SUNSHINE COAST REGIONAL DISTRICT

HALFMOON BAY (AREA B) ADVISORY PLANNING COMMISSION MEETING AMENDED AGENDA

SUBJECT: Development Variance Permit DVP00099 (7531 Cove Beach Road) –
Electoral Area B

SUBJECT: Development Variance Permit DVP00099 (7531 Cove Beach Road) - Electoral Area B

SHEET TITLE
**PROPOSED SITE
PLAN-POOL
DESIGN**

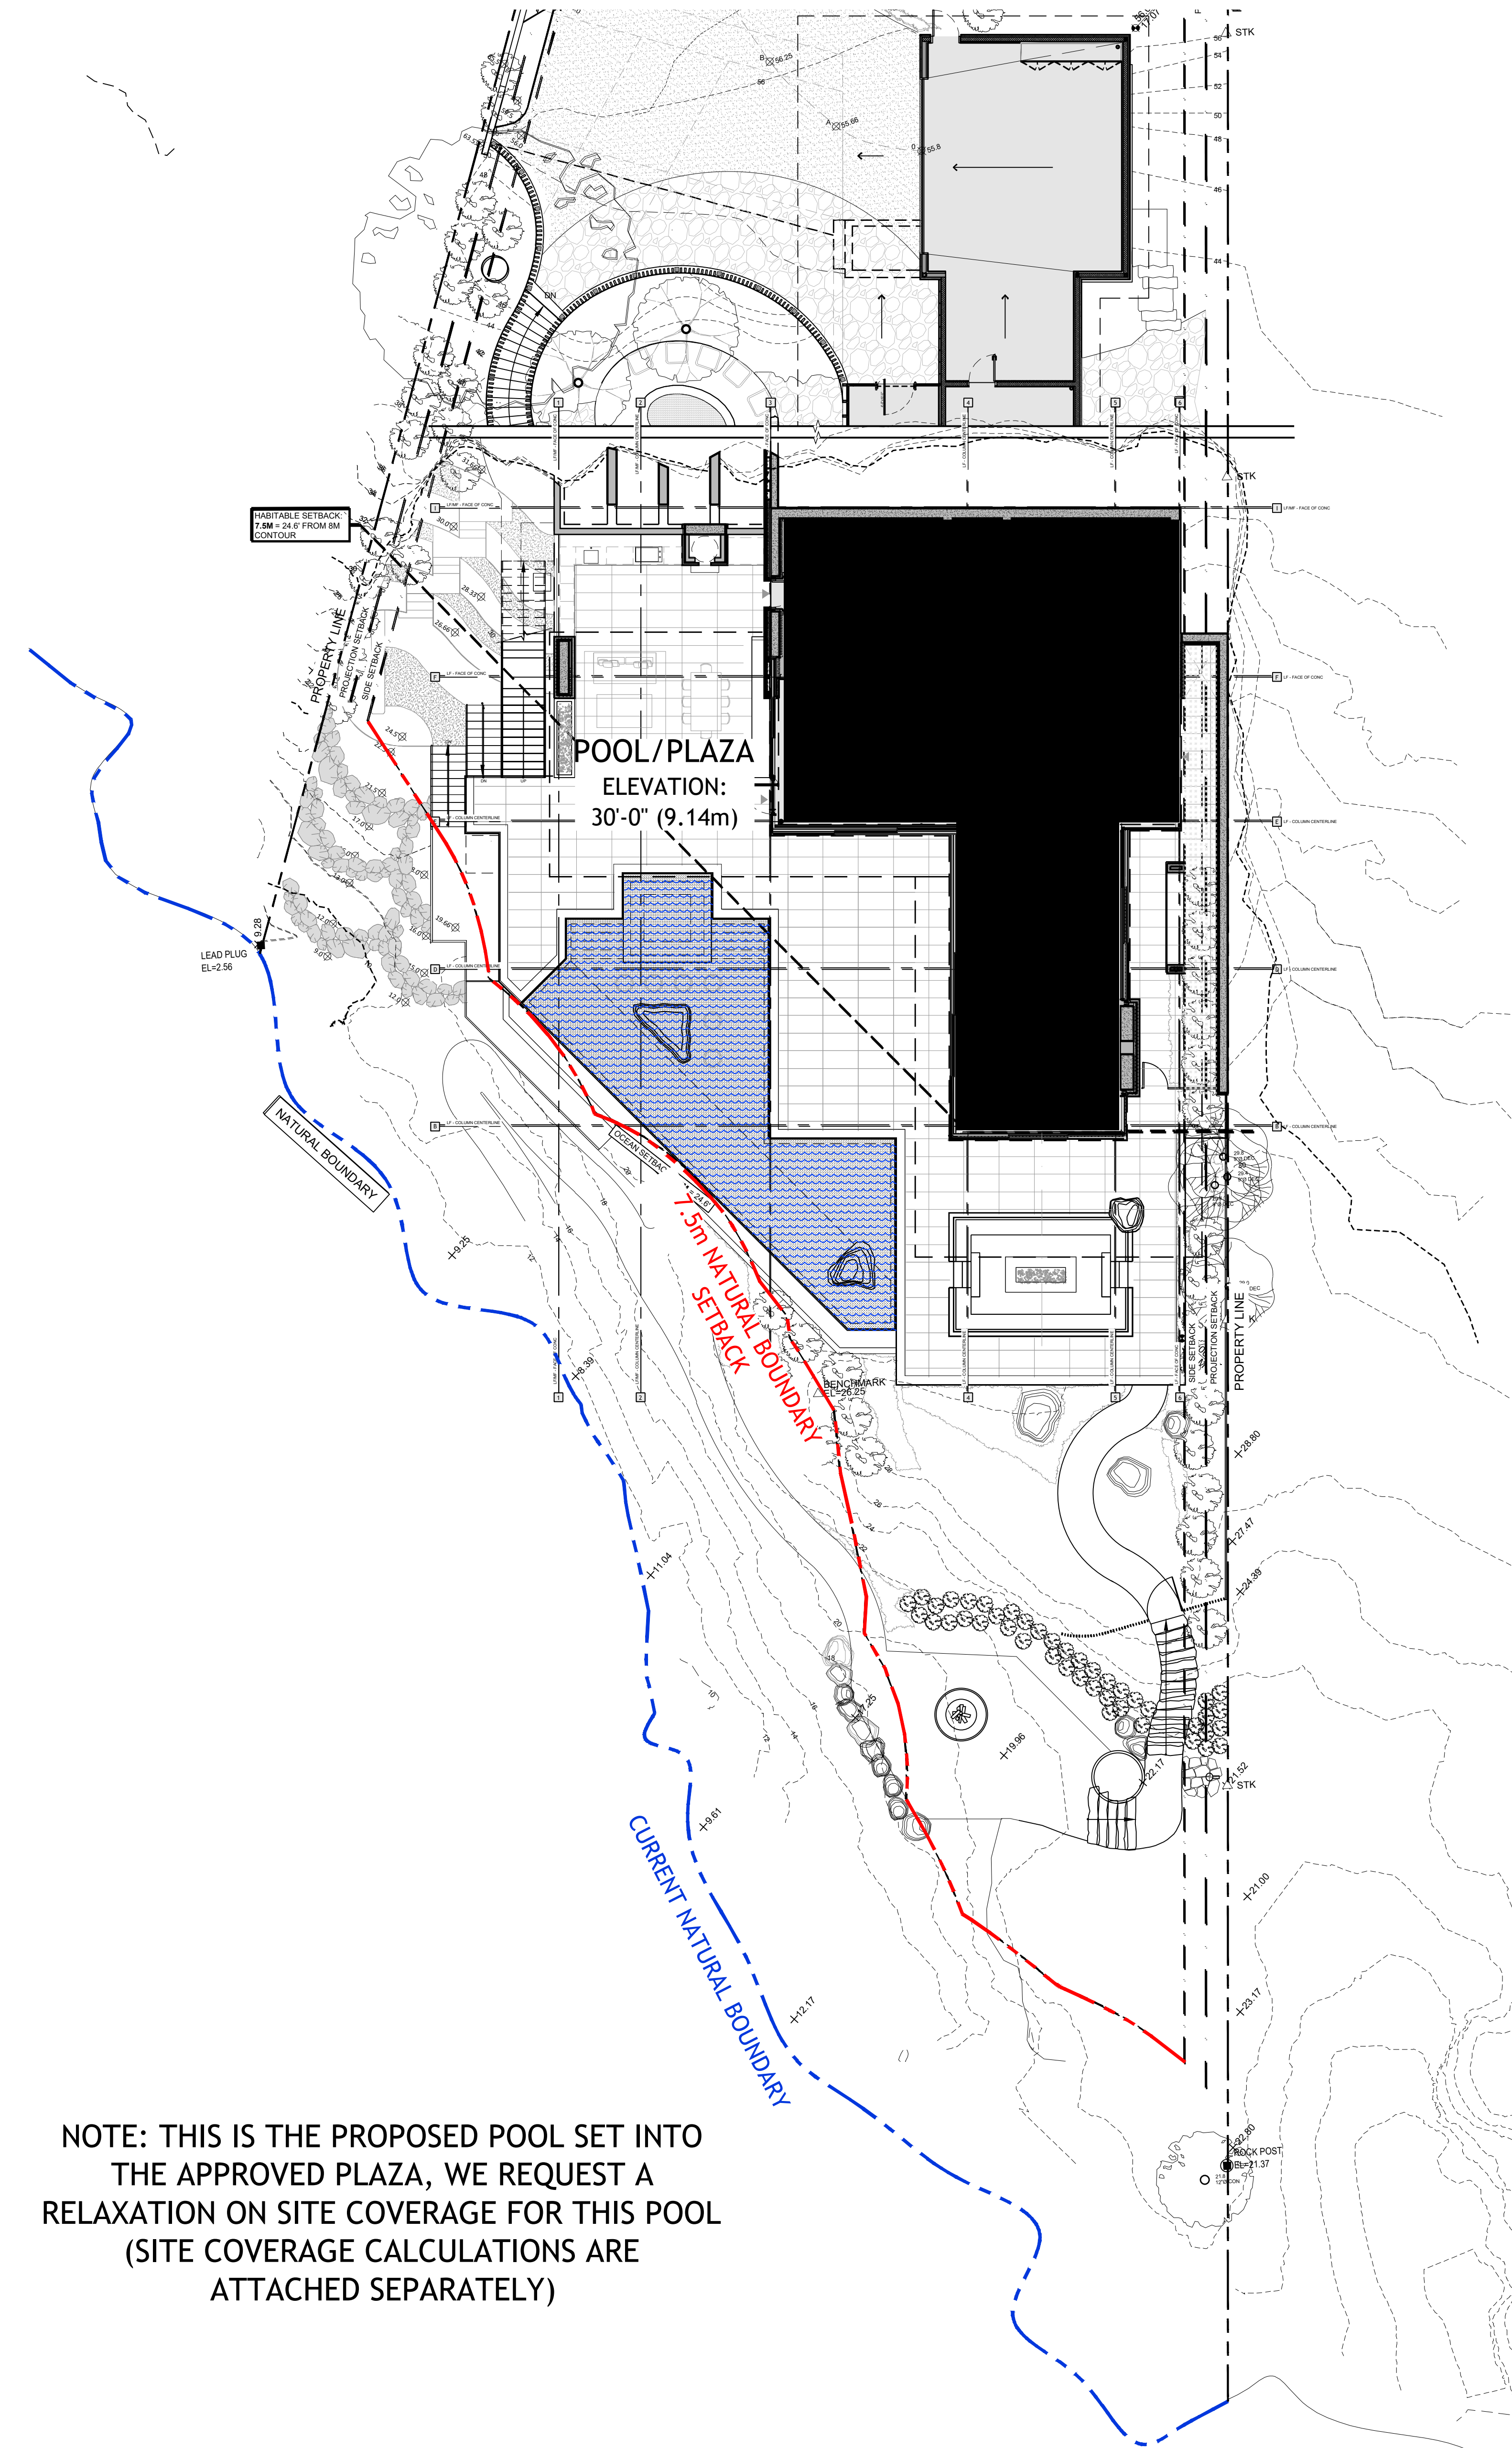
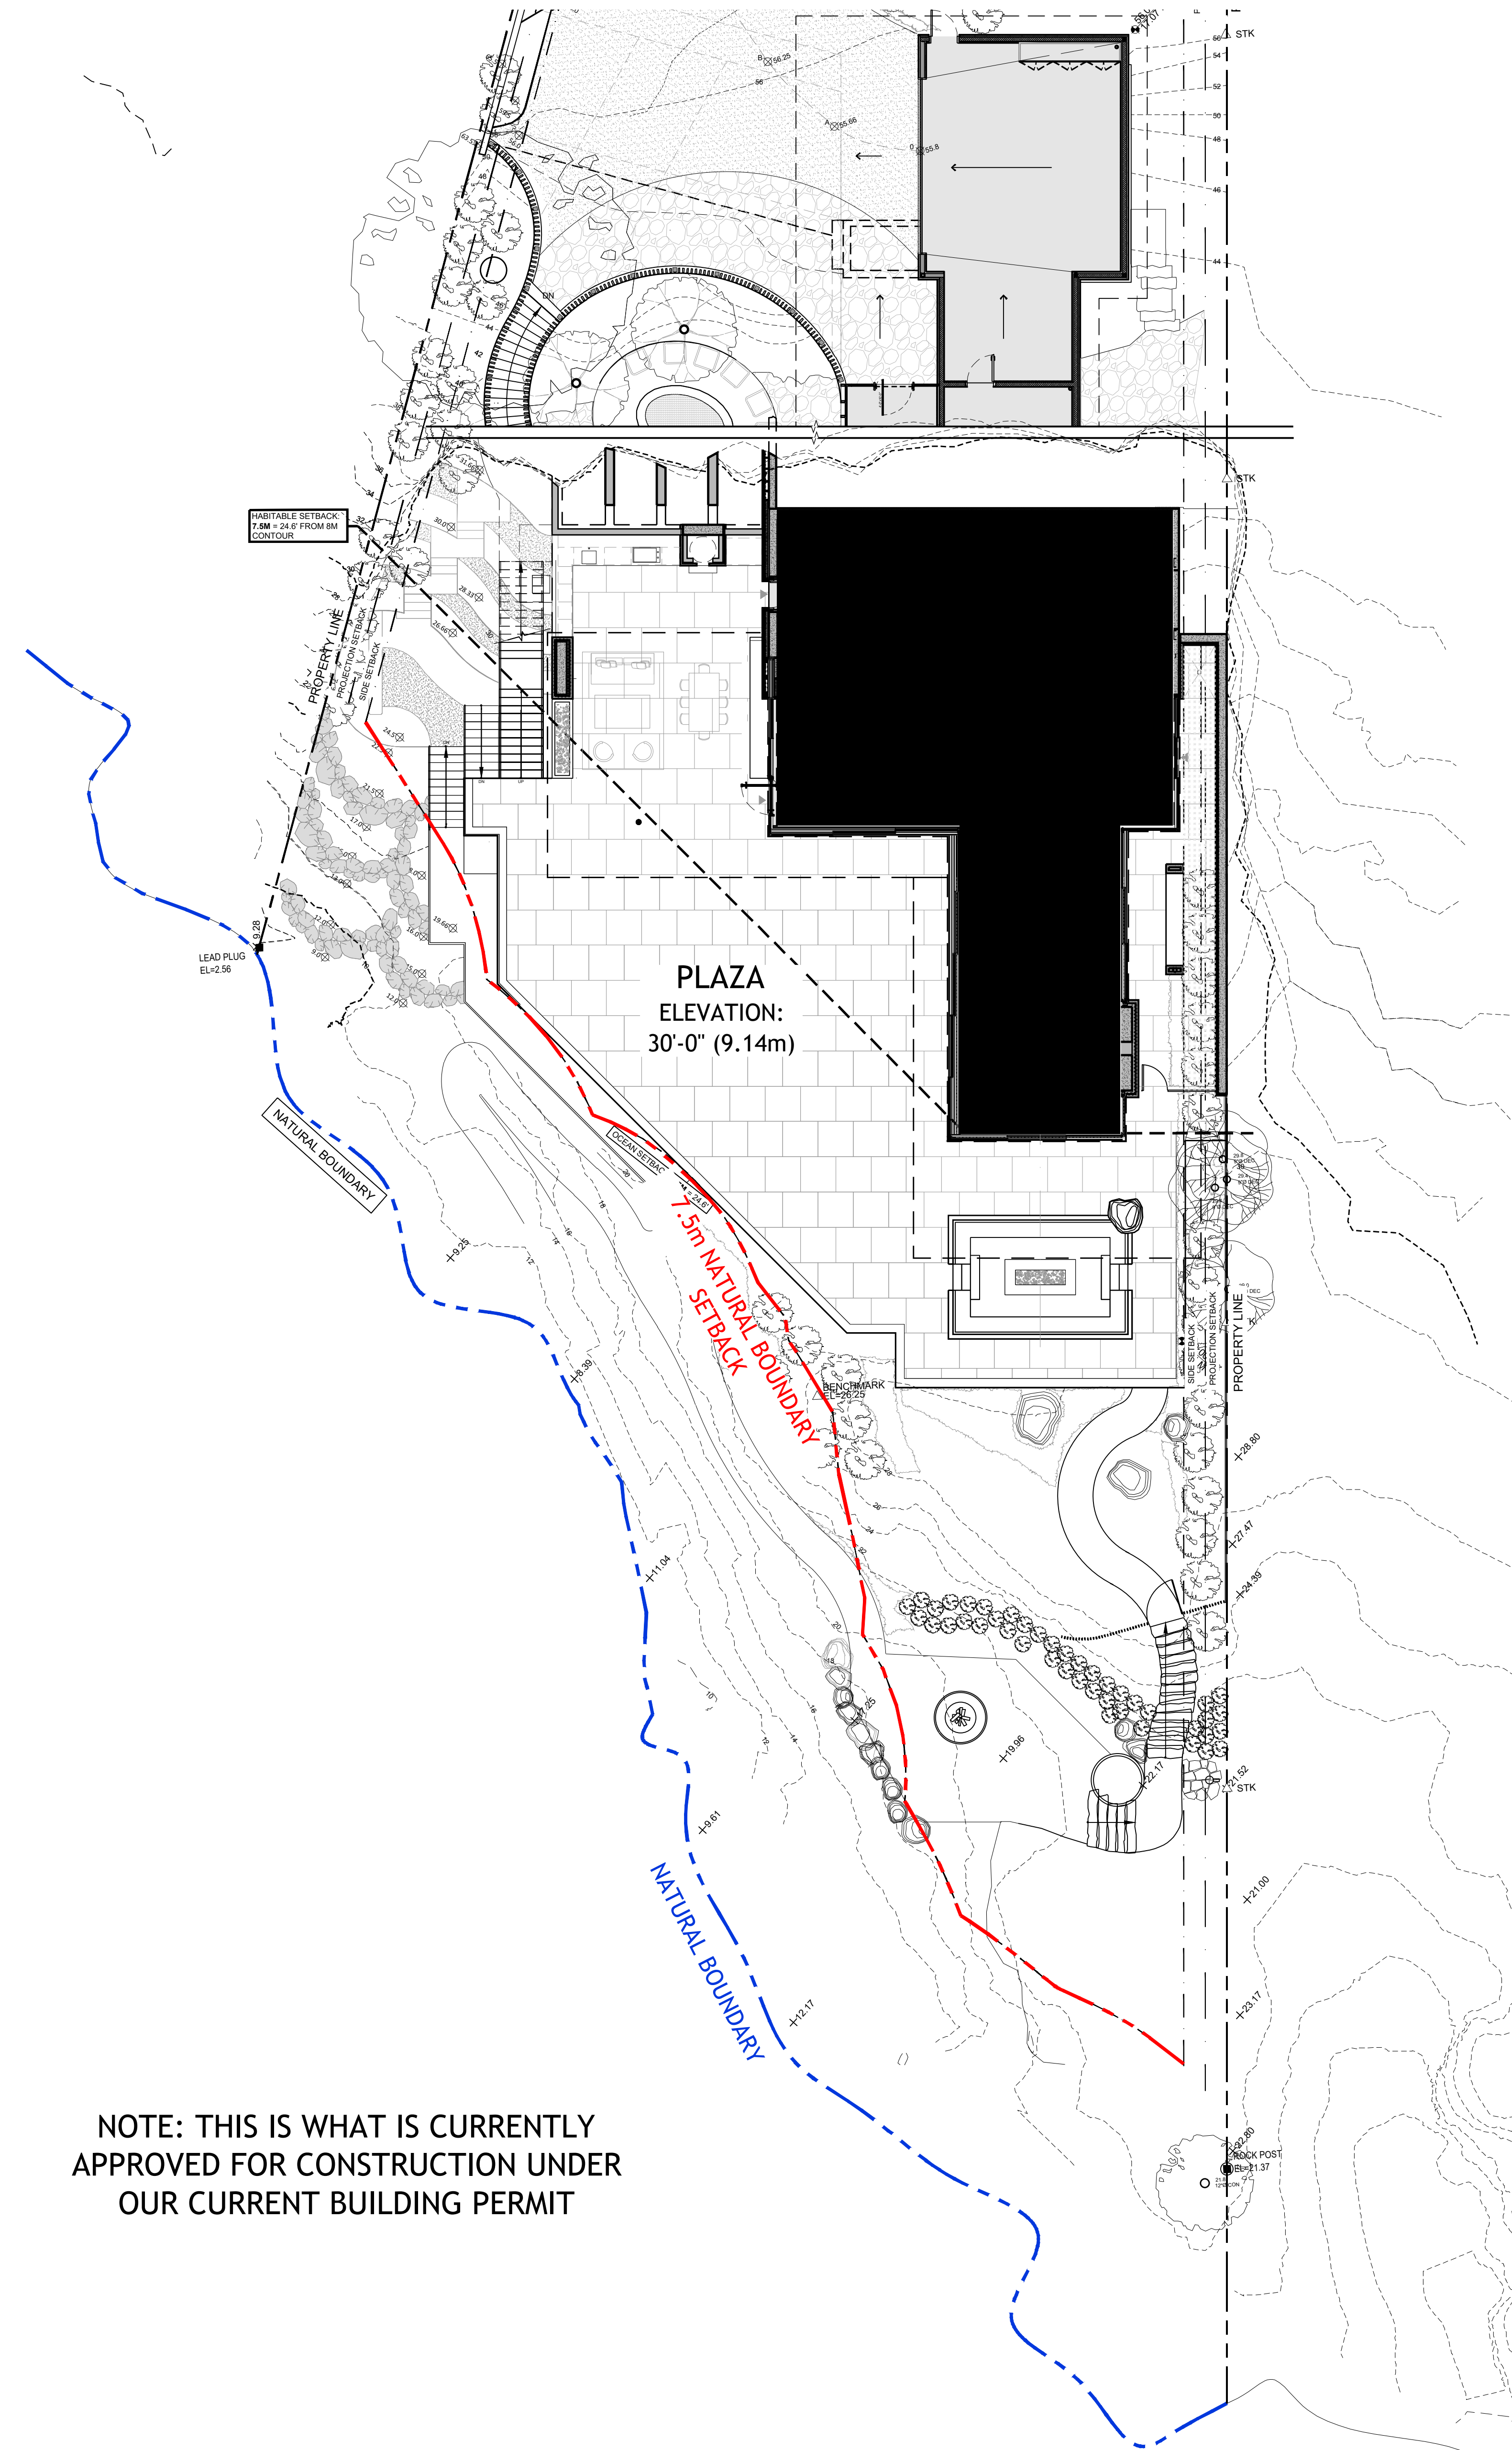
The proposed pool is considered a structure and in order to be constructed at the proposed location, a variance is required to the natural boundary setback from 15 m to 7.5 m.

The proposed setback variance from 15 m to 7.5 m is for the construction of the swimming pool. There is a plaza being constructed in the area where the pool is proposed, which was included as part of the Building Permit plans for the single-unit dwelling. The Building Permit was approved under Zoning Bylaw 310, which only required a 7.5 m setback. As the pool was not part of the original Building Permit, it is now subject to Zoning Bylaw 722, which requires a 15 m setback resulting in the request for a variance. As noted, in relation to the parcel coverage above, the location of a swimming pool has no further tangible impact or encroachment than the construction of a plaza would, so staff are supportive of the proposed variance given this context.

The existing By-law setback for a structure adjacent to the natural boundary is intended to reduce visual trespass, increase natural open spaces, provide an adequate buffer zone to the tidal area, free public waterfront access and this Lot is designated in the OCP as a Future Waterfront Park opportunity. Reducing the setback requirement will infringe on these objectives.
